Subject: Duke Energy Carolinas, LLC
William States Lee III Nuclear Station - Docket Nos. 52-018 and 52-019
AP1000 Combined License Application for the
William States Lee III Nuclear Station Units 1 and 2
Response to Request for Additional Information
(ER RAI 207, ER RAI 208, ER RAI 212, ER RAI 214, ER RAI 215, and ER
RAI 219)
Ltr# WLG2010.09-08

Lee Nuclear Station Response to Request for Additional Information (RAI)

Reference NRC RAI Number: ER RAI 207, Ecology - Aquatic

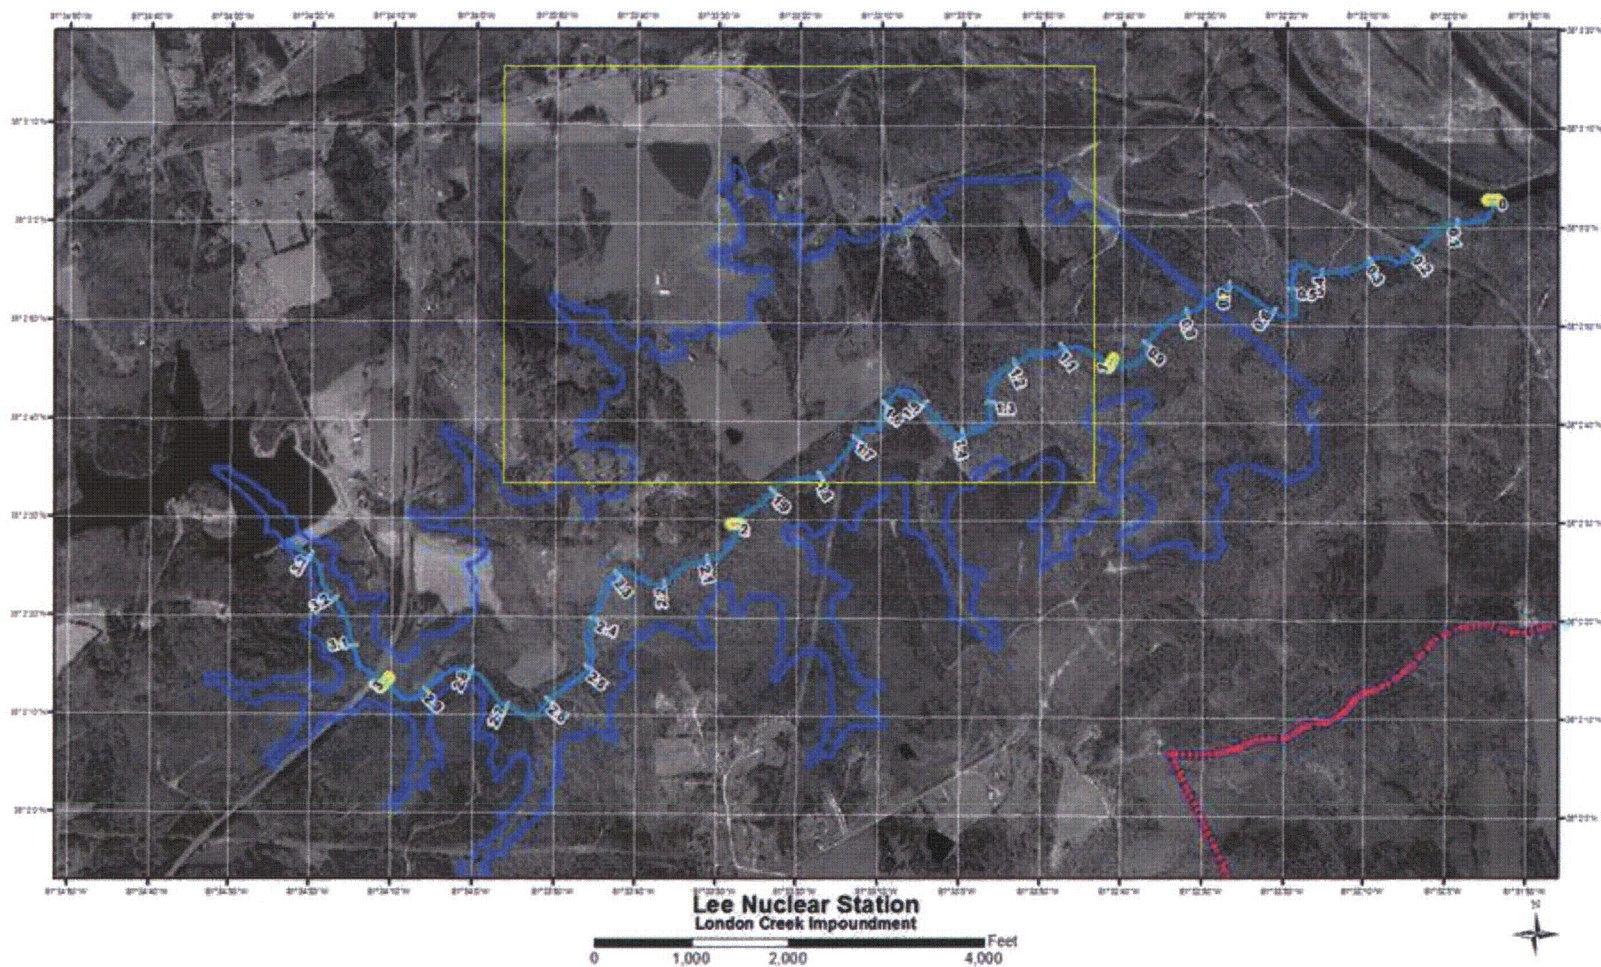
Provide a copy of the report on electro-fishing and other sampling conducted to survey aquatic species found in the farm ponds after it is finalized.

The requested report is provided as Attachment 208-1.

Fish collections occurred at seven pond locations (Bob's Pond and Ponds F1 - F6) northwest of the London Creek-Broad River confluence and within or near the proposed reservoir boundary (Figures 1 and 2).
